BID ADDENDUM NO.1

2181539 Bank on Buffalo, Niagara Falls, NY

There was an error during the printing process that caused the structural & HVAC items to not appear in the Architectural drawings. Some of the drawings being replaced are only to show the missing items for clarification. No actual changes are occurring on these sheets. Any changes to the drawings are clouded & tagged.

A502

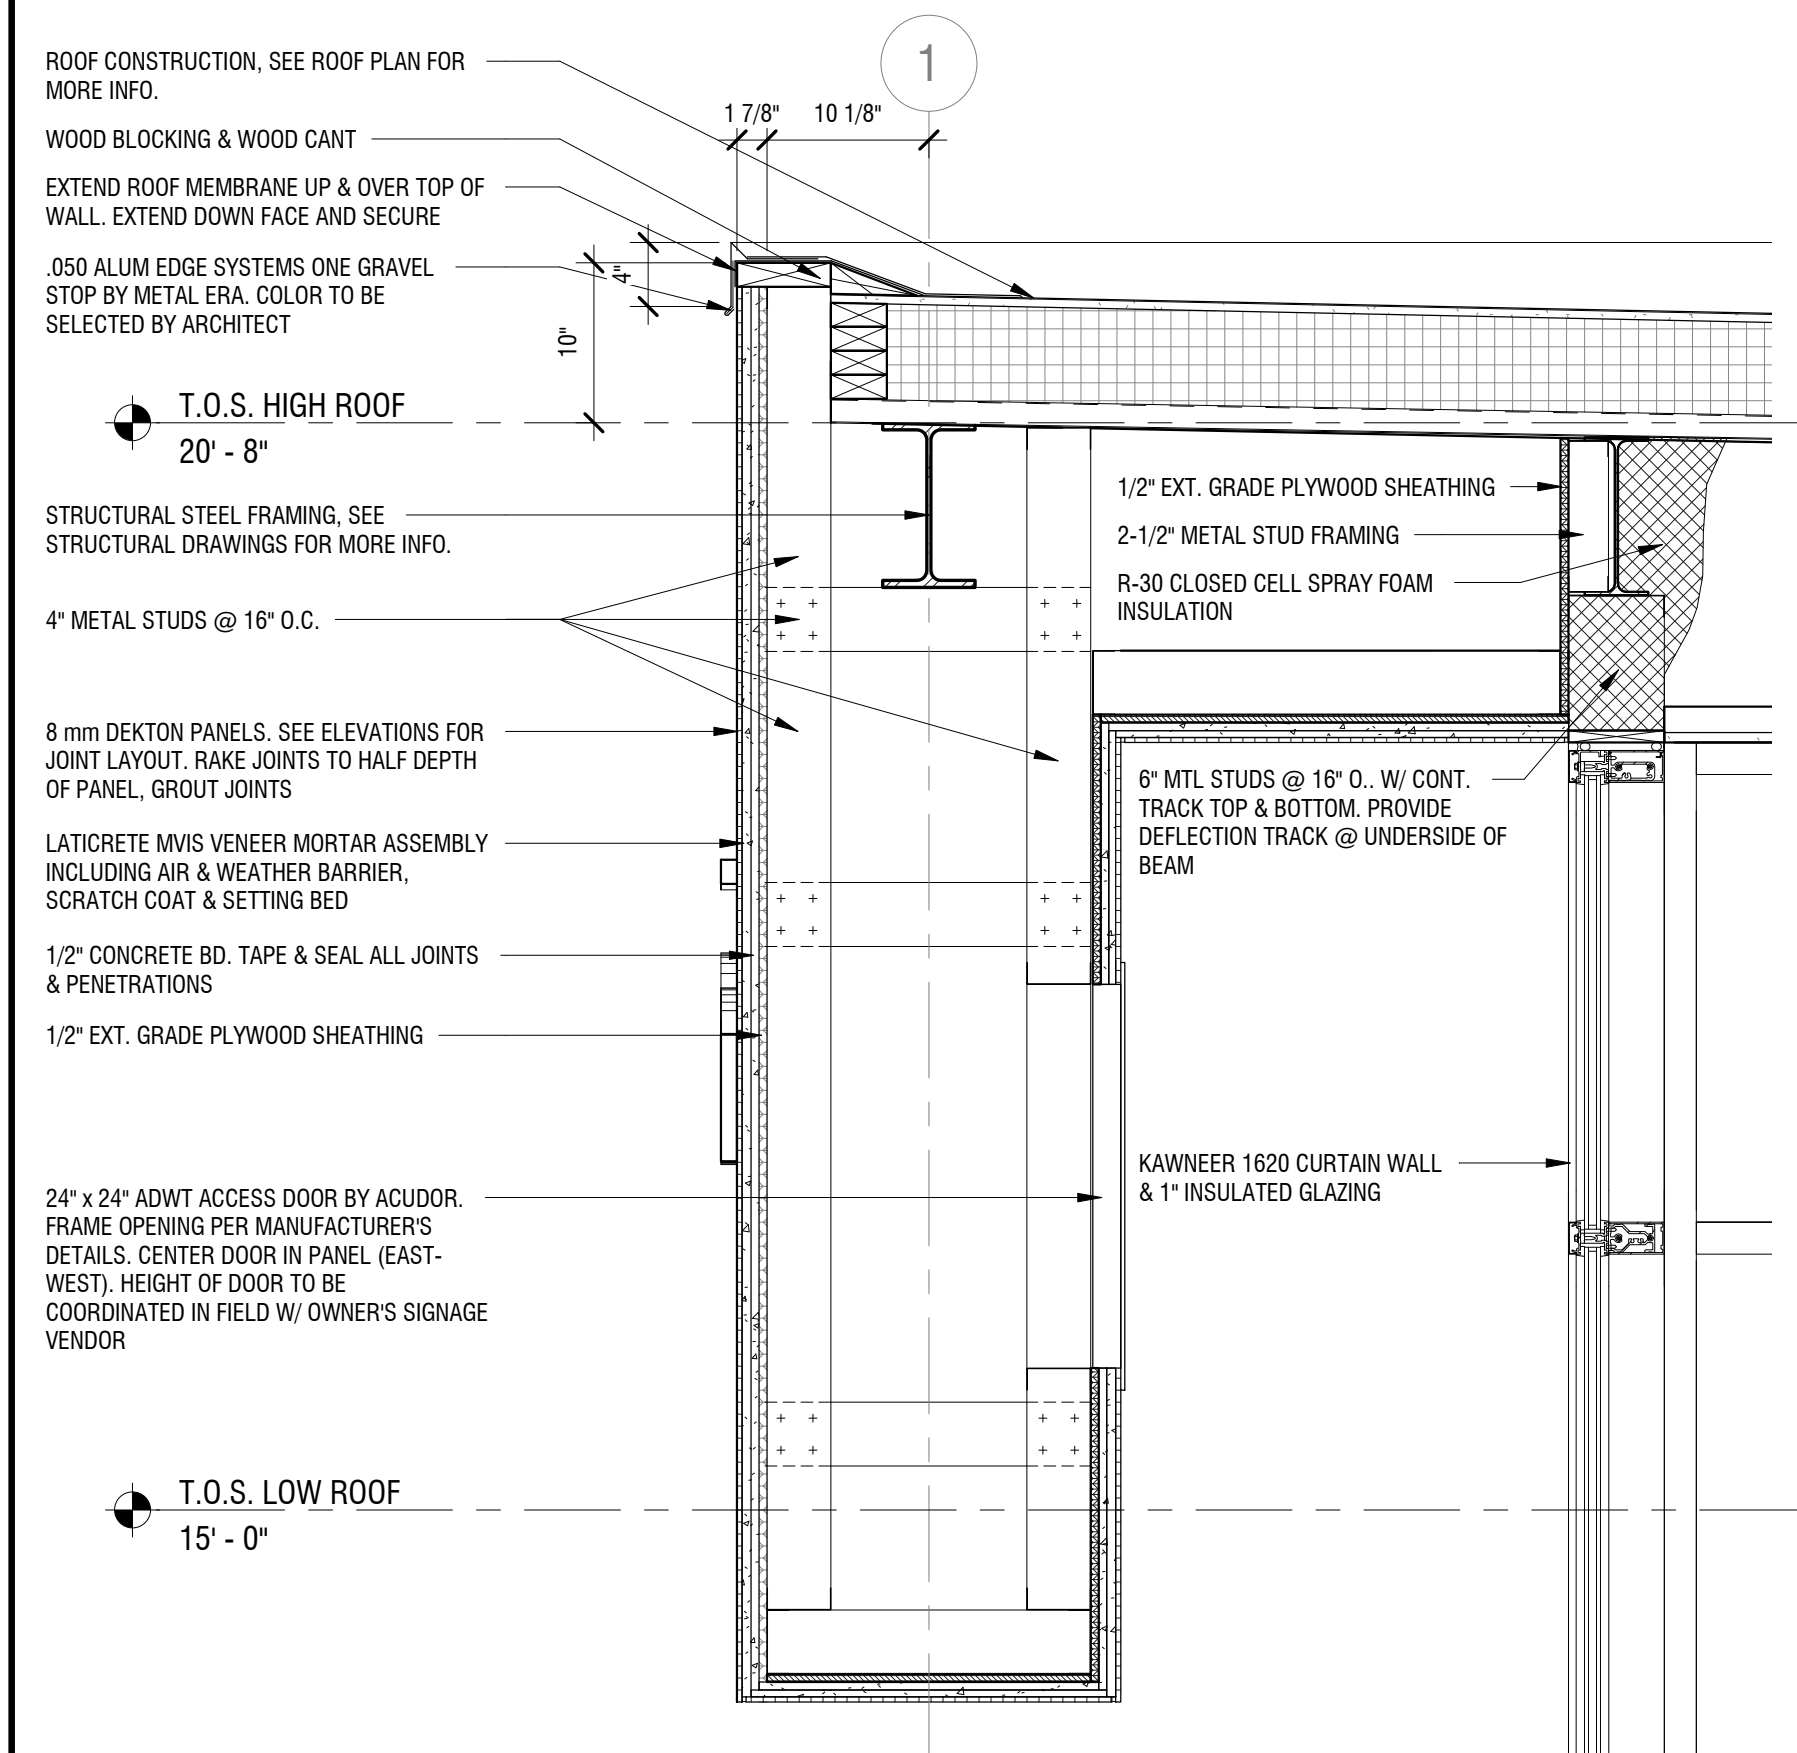
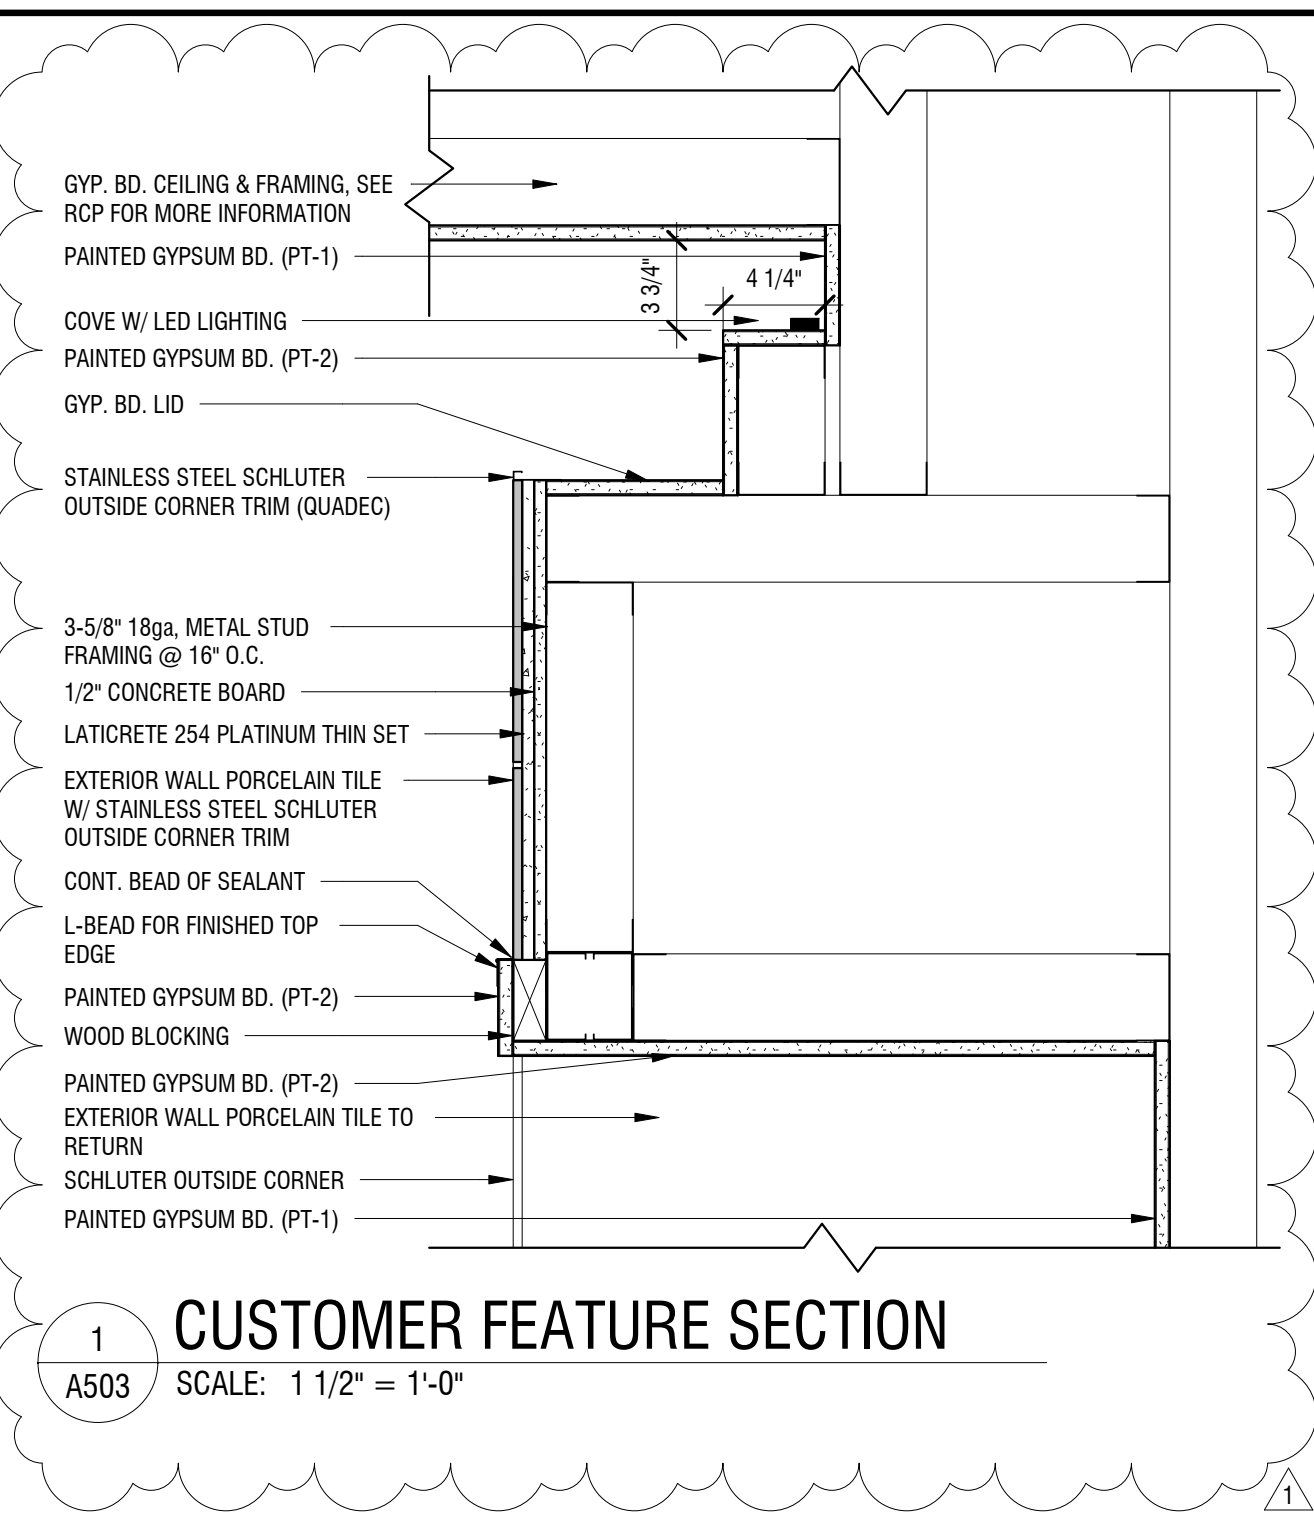
- N. Drawing A502**
 - 1. DELETE Drawing in its entirety
 - 2. ADD replacement Drawing A502
 - 3. Structural items are now shown on drawings.
